Standup 2.0
Label Updates
July 2024

Reason for Change: SBC Gen 1 → Gen 2

Bevi SBC Gen 2 Labeling

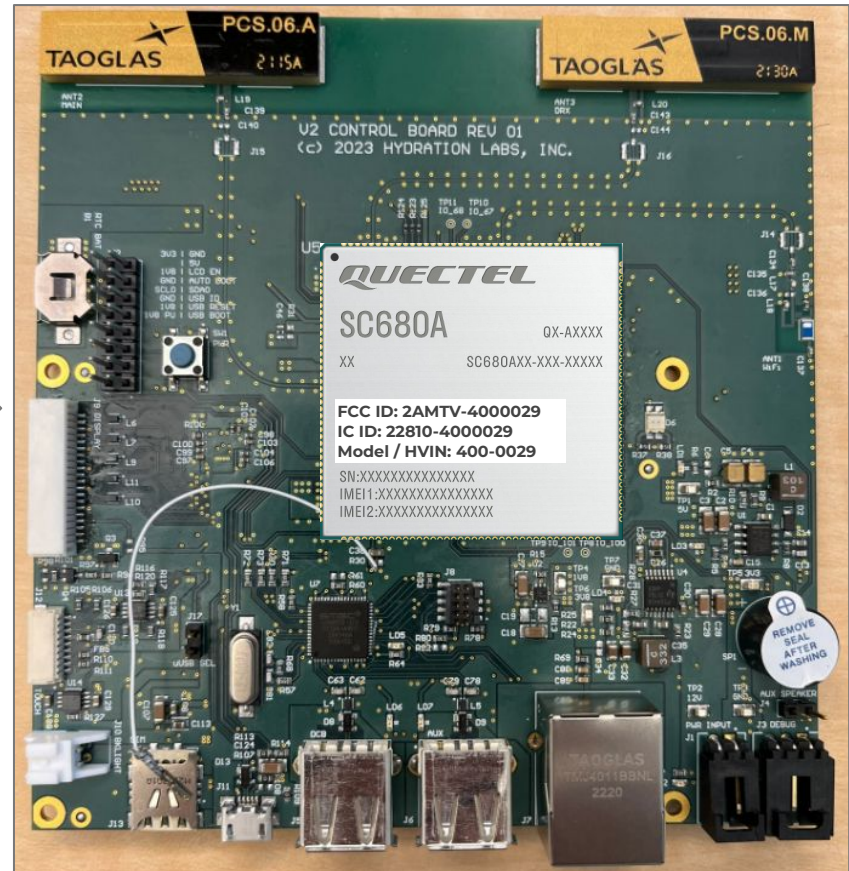
- Label placed on Quectel SC680A SOM must cover Quectel's FCC and IC ID's
 - ADD actual FCC ID: 2AMTV-4000029
 - ADD actual IC ID: 2AMTV-4000029

Standup 2.0 Product & Serial Labels

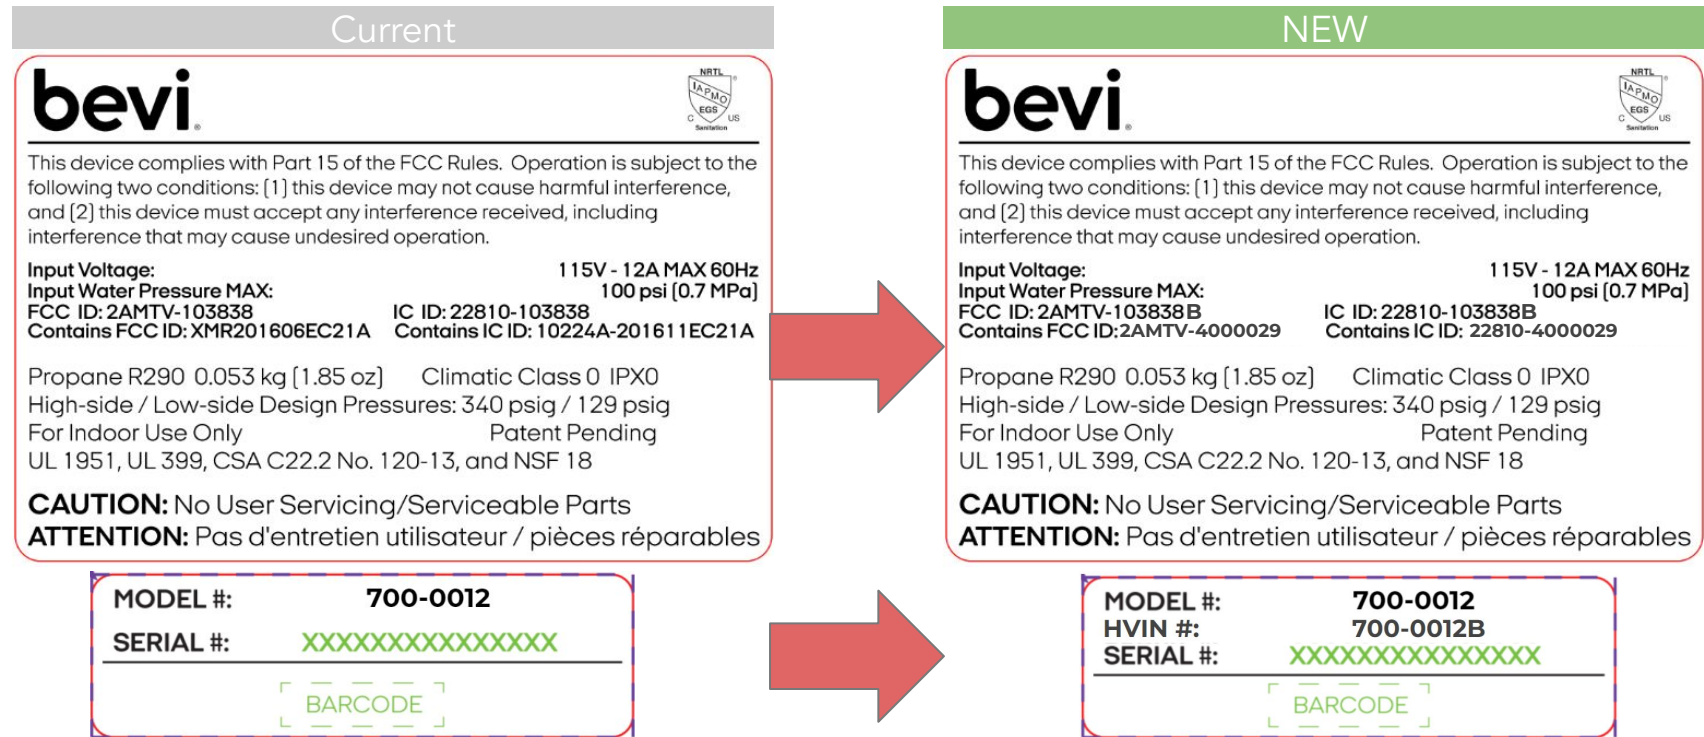
- **Product Label - Bevi PN 107171-01**
 - CHANGE actual FCC ID: 2AMTV-103838B
 - CHANGE actual IC ID: 22810-103838B
 - CHANGE reference FCC/IC ID's for our Gen 2 SBC
- **Model / Serial Number Label - Bevi PN 107461-01**
 - ADD HVIN: 700-0012B

Standup 2.0 Product & Serial Label Placement

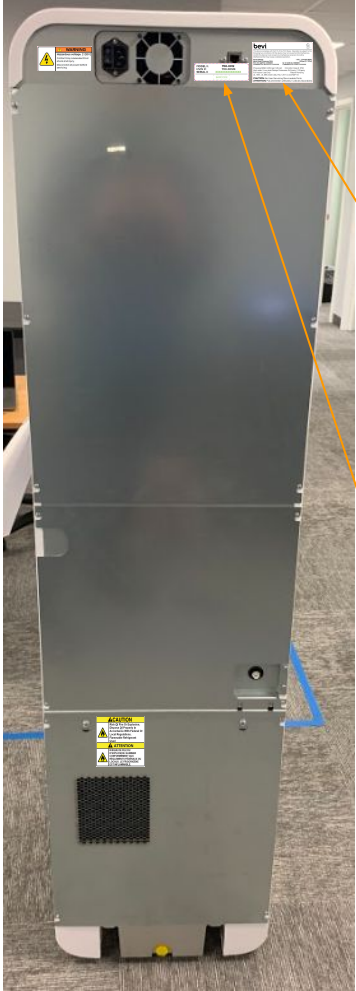
Input Voltage:	115V - 12A MAX 60Hz
Input Water Pressure MAX:	100 psi [0.7 MPa]
FCC ID: 2AMTV-103838B	IC ID: 22810-103838B
Contains FCC ID: 2AMTV-4000029	Contains IC ID: 22810-4000029

MODEL #:	700-0012
HVIN #:	700-0012B
SERIAL #:	XXXXXXXXXXXXXXXX
